LiDAR Quality Assessment Report

IN_WesternTier-Block11_2013

NGTOC

Downstream DLS Flow is Stairstepped

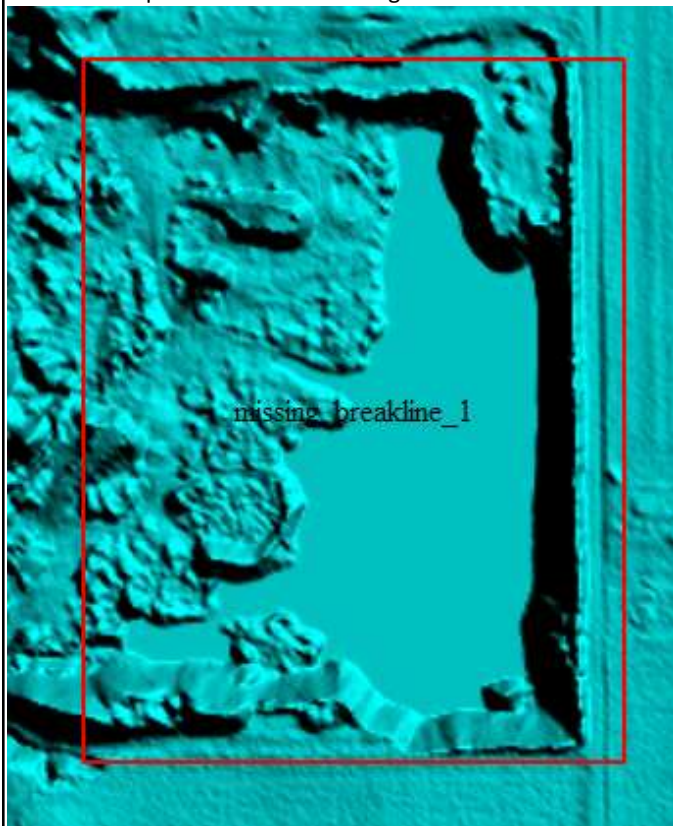
See error shapefile to correct missing breakline issues.

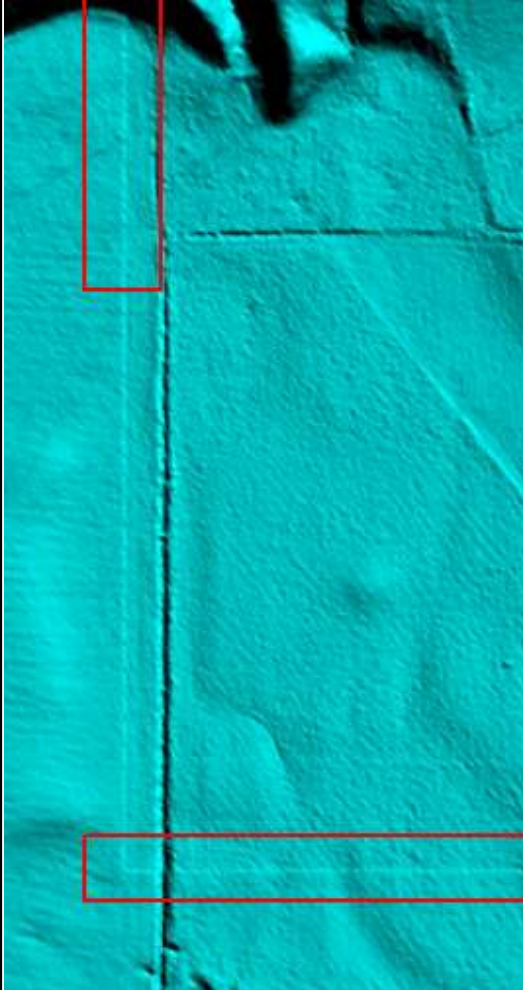
Edges visible where tiles meet, see error shapefile

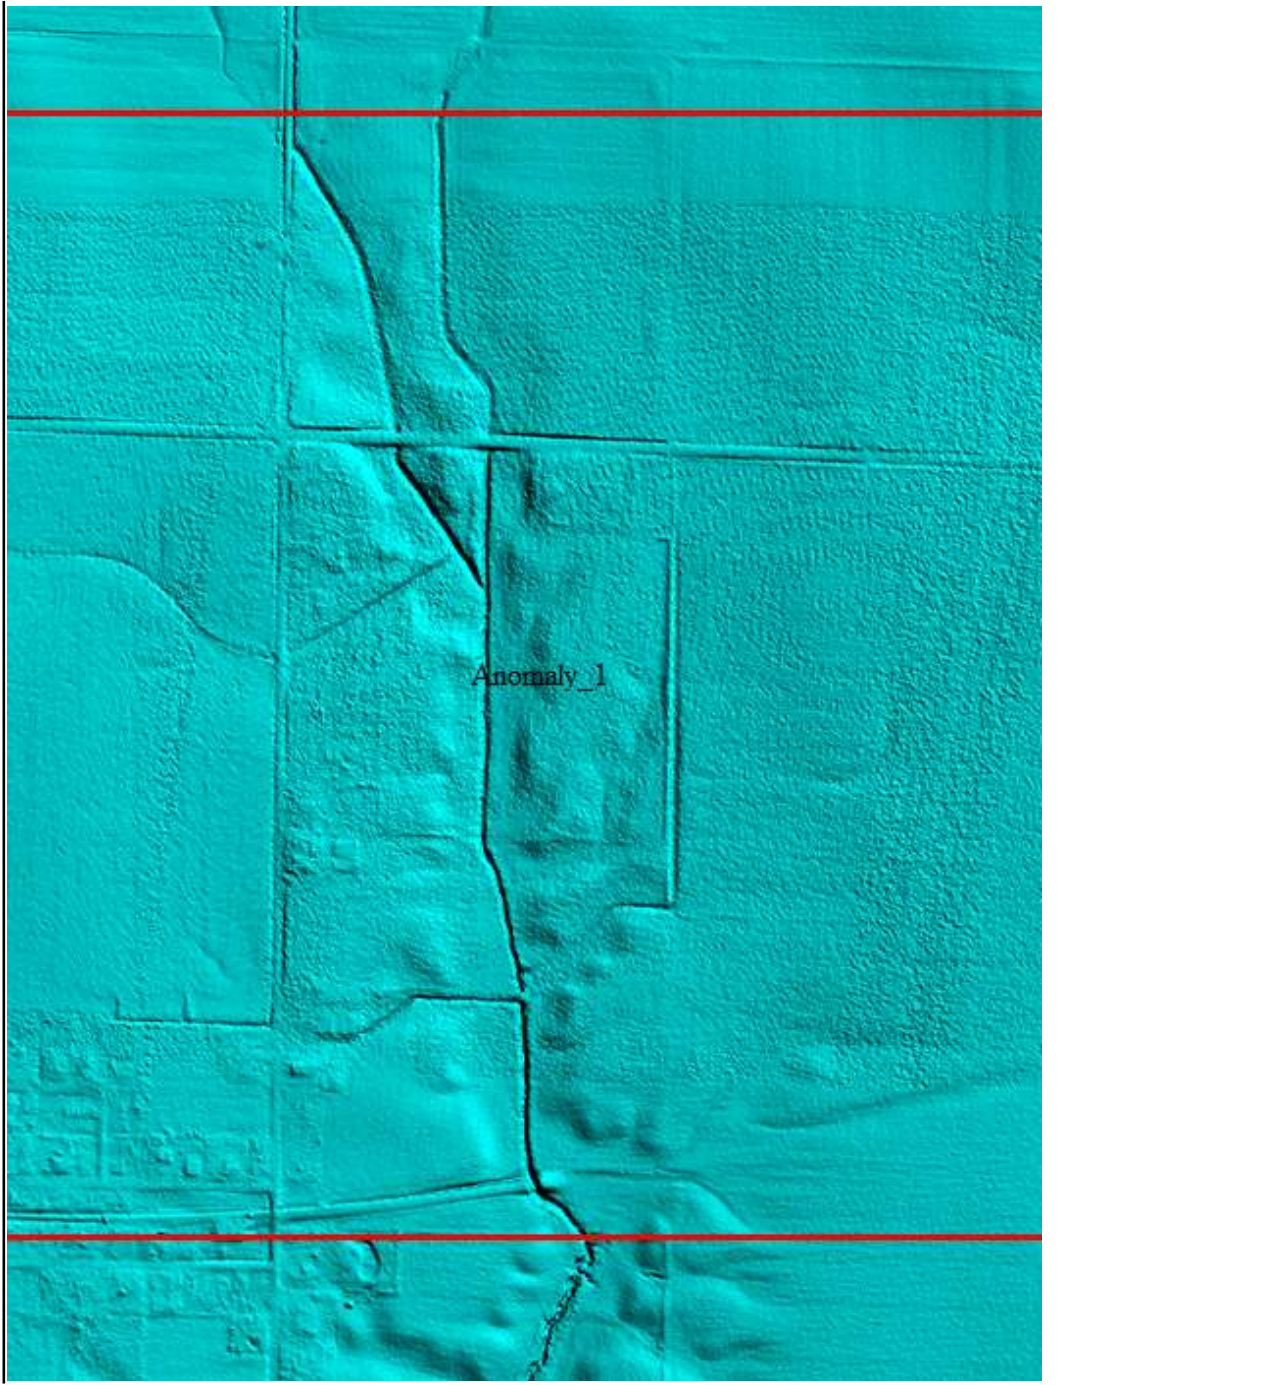
Pattern changes seem to be due to sensor error

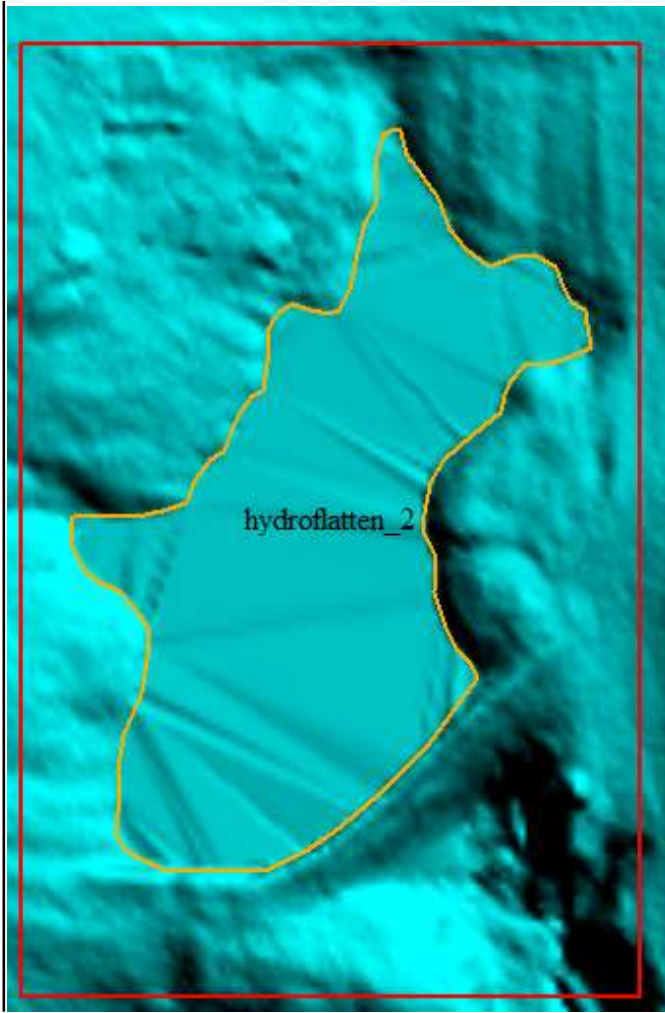
Water bodies greater than 2 acres should be hydroflattened

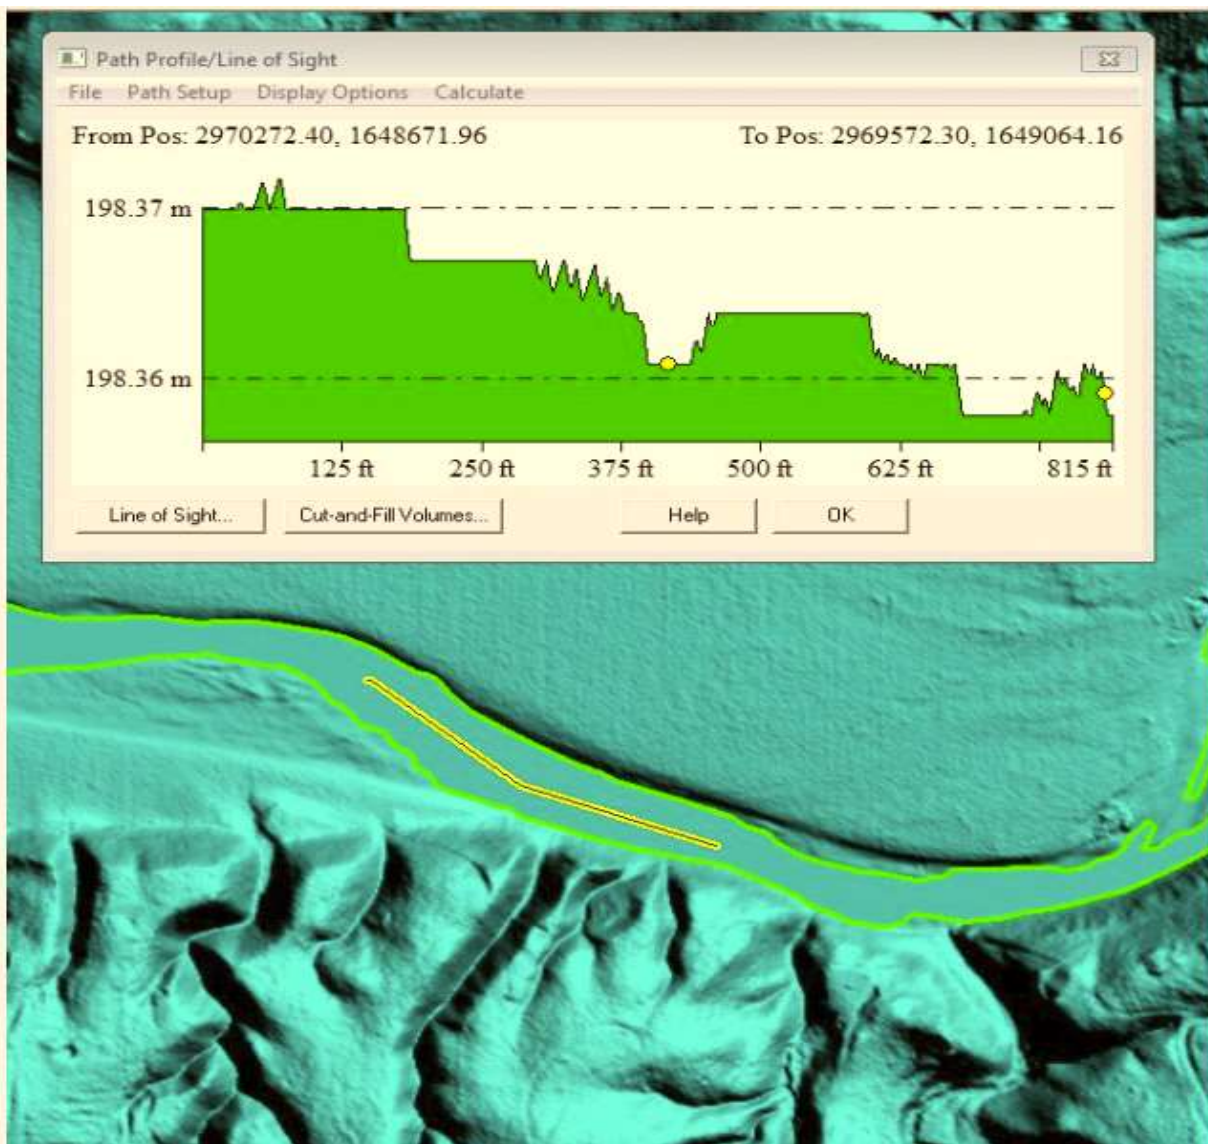
Streams need to be flattened in consistent downhill flow, fix hydroflattening errors that contain peaks and valleys

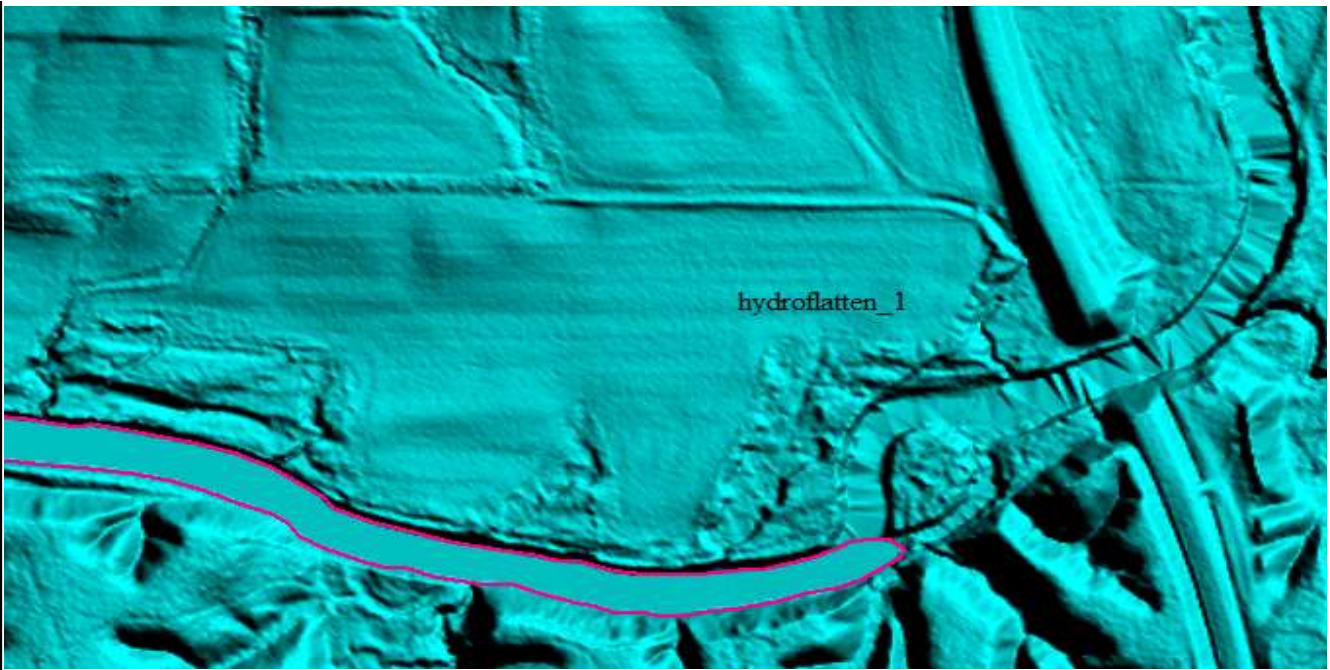
Hydroflattening of this stream/river is inconsistent. It is unclear why the hydroflattening process was completed up to this point then stopped

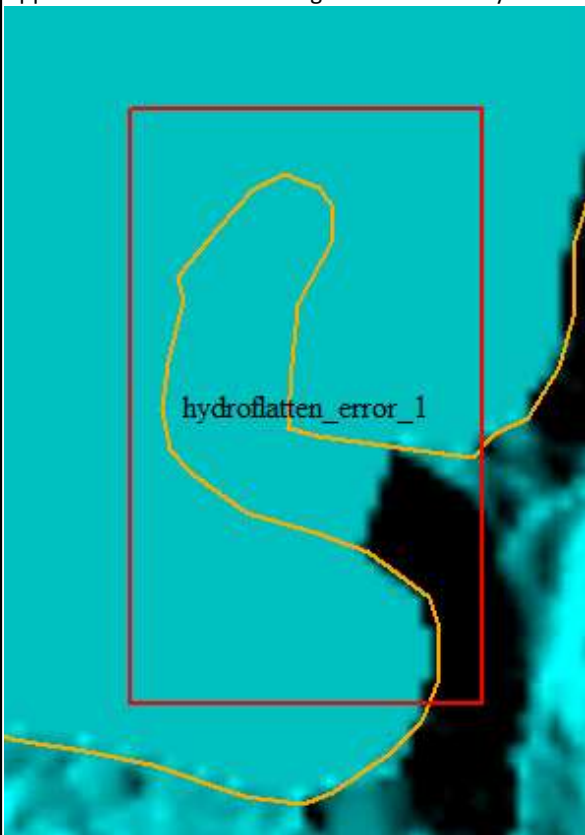
Apparent land mass is missing from water body

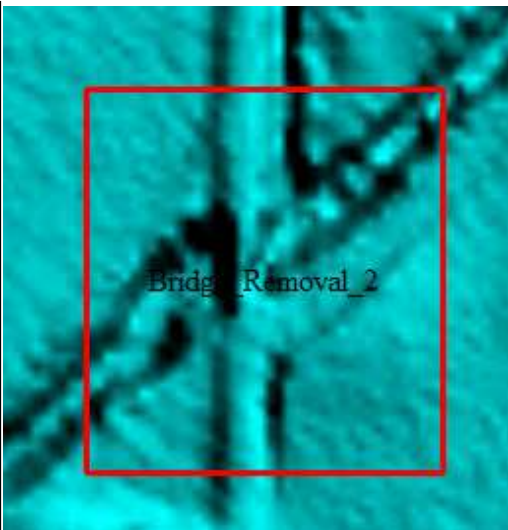
Some bridges not completely removed

Please remove bridge remnants

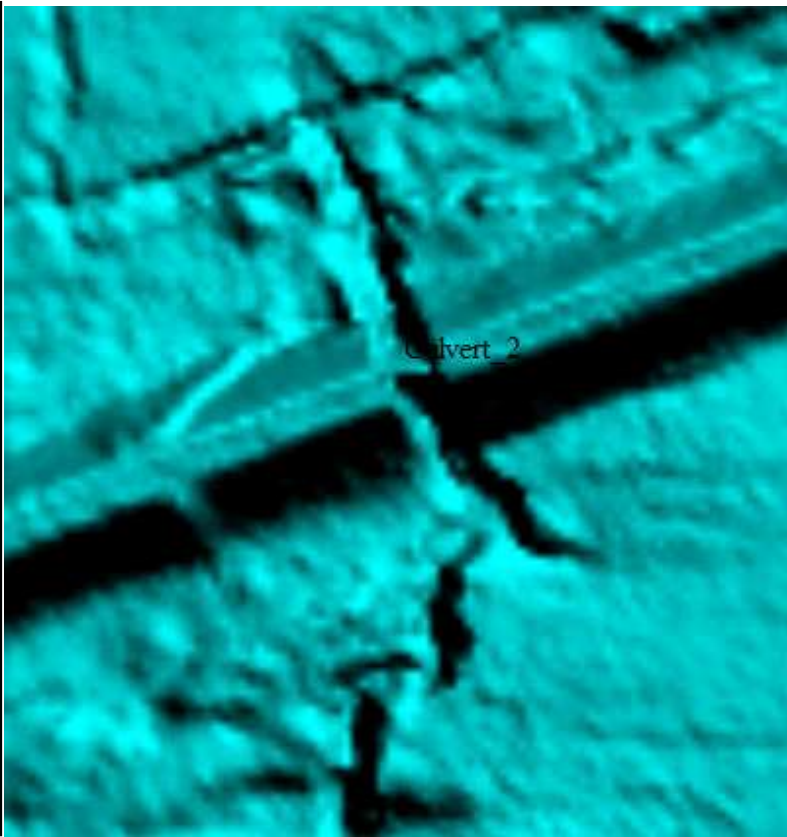
Some culvert have been removed, please replace culverts

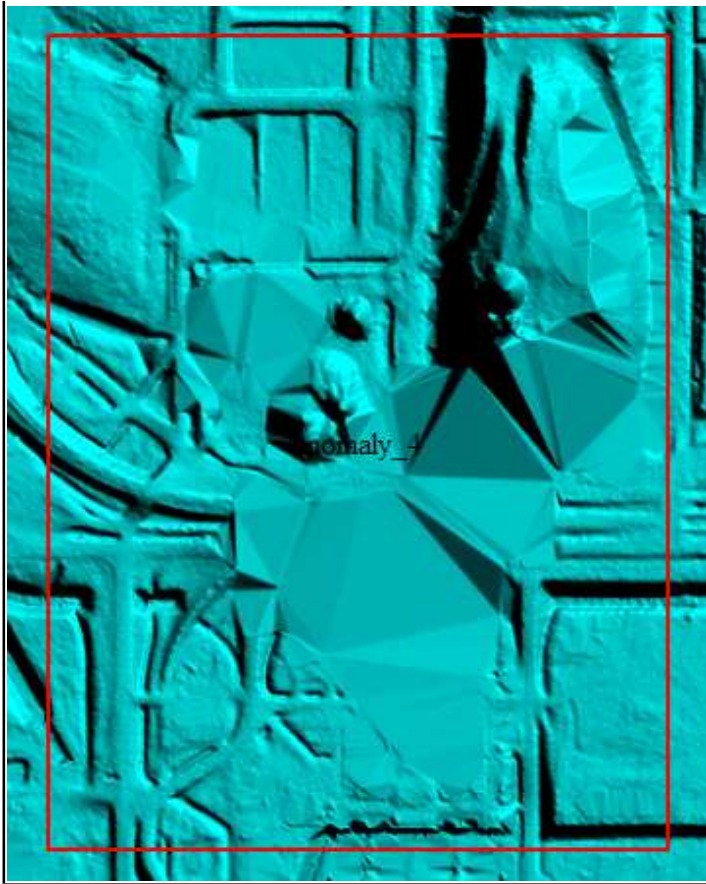
Unknown removal causing excessive tinning of area, please correct or explain
